KDFWR Executive Summary of Services Rendered by VizionAir

Unmanned Aerial System Elk Survey
Doc ID No: PON2 660 1700001306 1

KNOTT, PERRY, AND HARLAN COUNTIES, KENTUCKY

Prepared for:
Kentucky Department of Fish and Wildlife Resources
Frankfort, KY

Image 6: IR signatures from elk and landscape features for comparison.

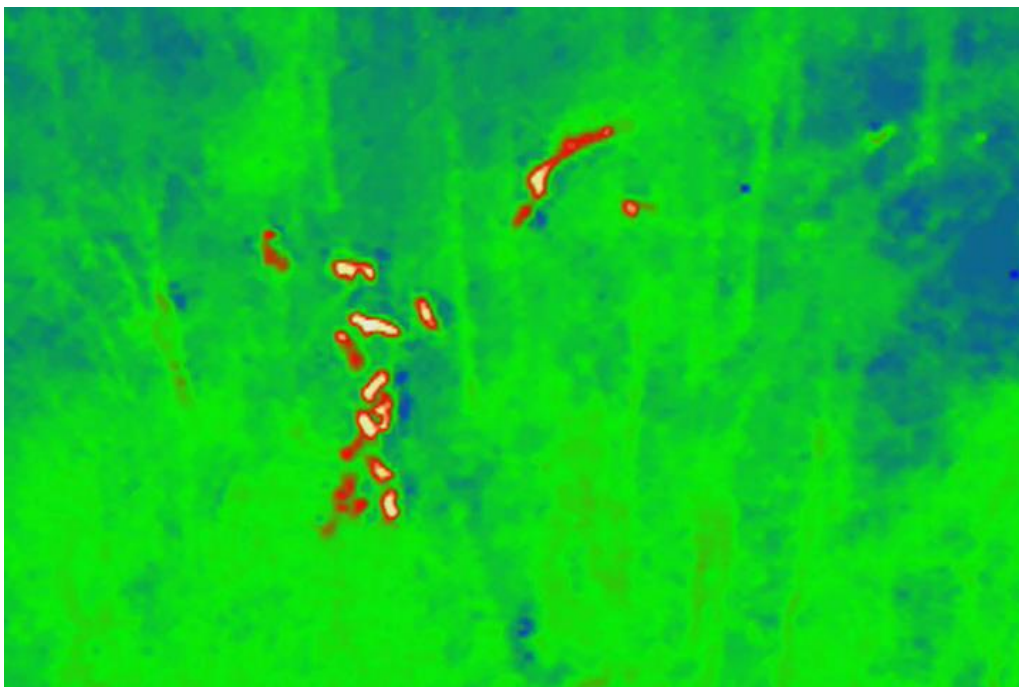
9. Page 7: “The relative temperatures of nearby non-biological features were sometimes warm enough to provide a heat signature similar to an endotherm (i.e., an animal that creates its own heat; Image 6)”

- a. Program commentary: It will be impossible to conduct counts at any time of year other than leaf off, but is still difficult under ideal situations with current technology.
